Look at TCTVB Issue at IR2

R. Assmann, T. Weiler, J. Jowett

Our analysis 8.1.2008

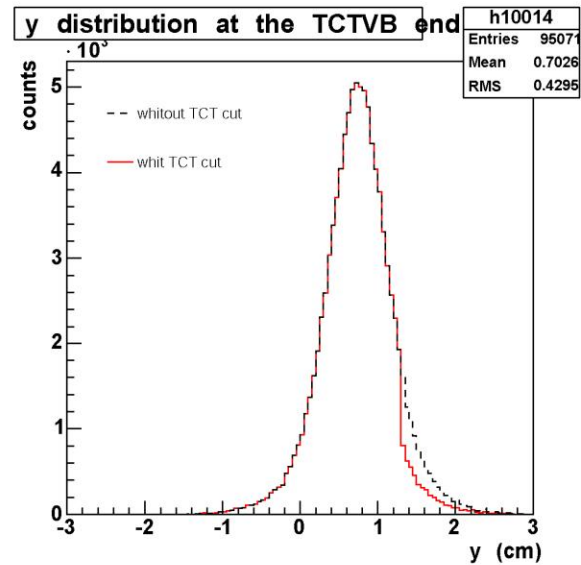
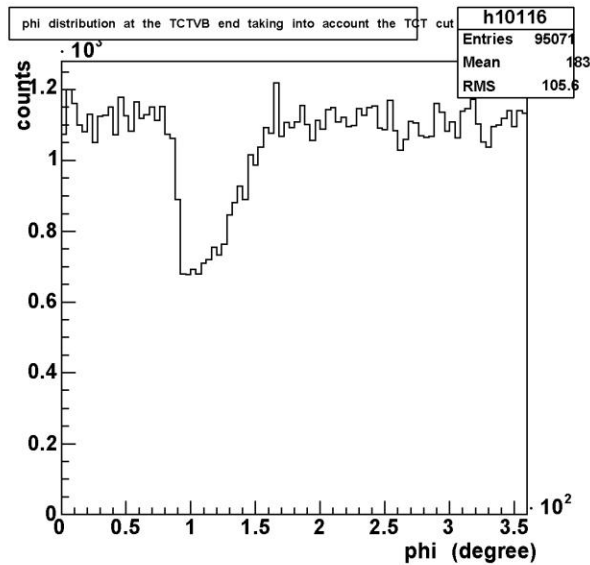
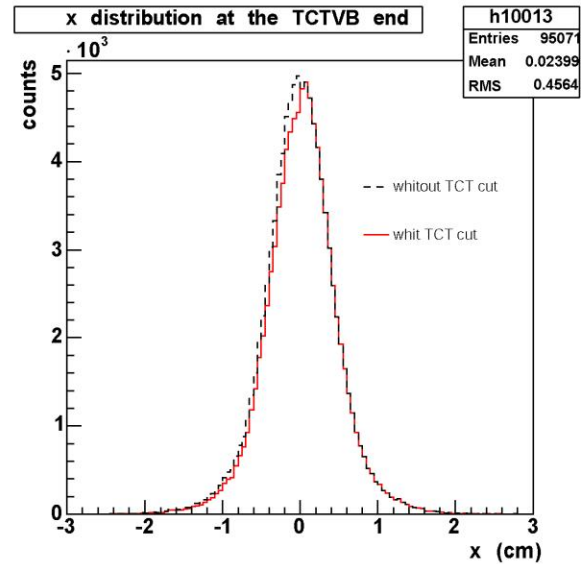
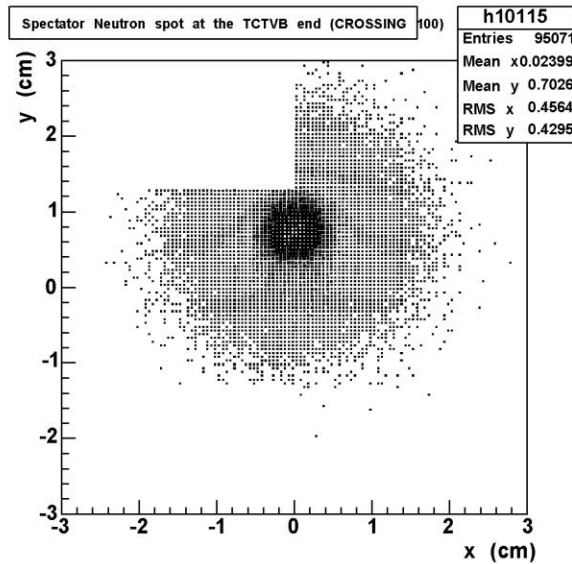
- Zero crossing angle: The number of spectator neutrons hitting the jaws is 0.8% and the phi distribution appears flat.
- 100 microrad crossing angle at IP2 with 30 microrad beam divergence: The number of spectator neutrons hitting the jaws is 5% and the phi distribution is not flat.
- First scenario OK.
- Still interested to reserve additional collimator locations → I am not yet convinced that this is needed.
- Further follow-up to clarify needs.
